FINDINGS OF FACT and FINAL ORDER TYPE II DESIGN REVIEW and ADJUSTMENT

DATE:	August 26, 2025
CASE NO:	25-041 DR/ADJ
PROJECT NAME:	US Metal Works - Building "D" Addition
ADDRESS:	37378 Industrial Way
MAP/TAX LOT:	24E14 01106
APPLICANT NAME:	Lyle Drucker
OWNER:	USMW#2 LLC
SIZE:	4.00 Acres
ZONING:	I-2 (Light Industrial)
STAFF:	Patrick Depa, Senior Planner

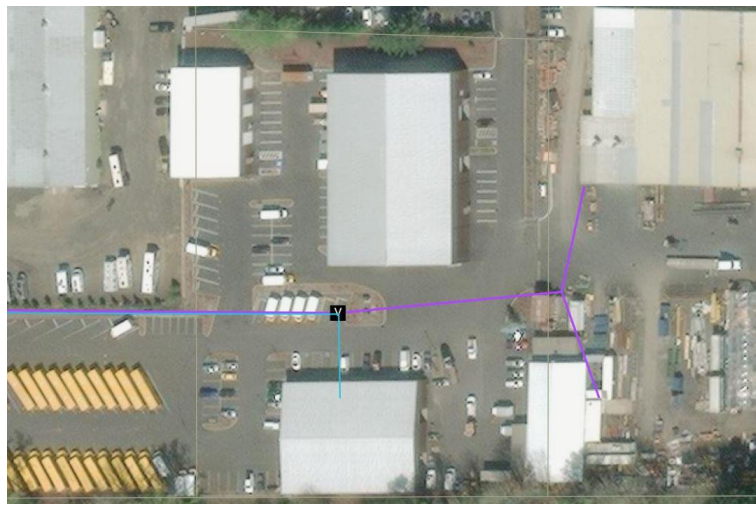
The Building Division will need to review civil engineered drawings addressing soil stabilization along the south property line after part of the building is removed due to proximity to the hill and history of the soil in this area sinking or shifting.

1. The Building Division will need to review civil engineered drawings addressing soil stabilization along the south property line due to proximity to the hill and history of the soil in this area sinking or shifting.
2. The applicant shall display the Building D identification on the north elevation for all patrons and emergency services to locate.
3. Install all improvements as approved with the building permit.
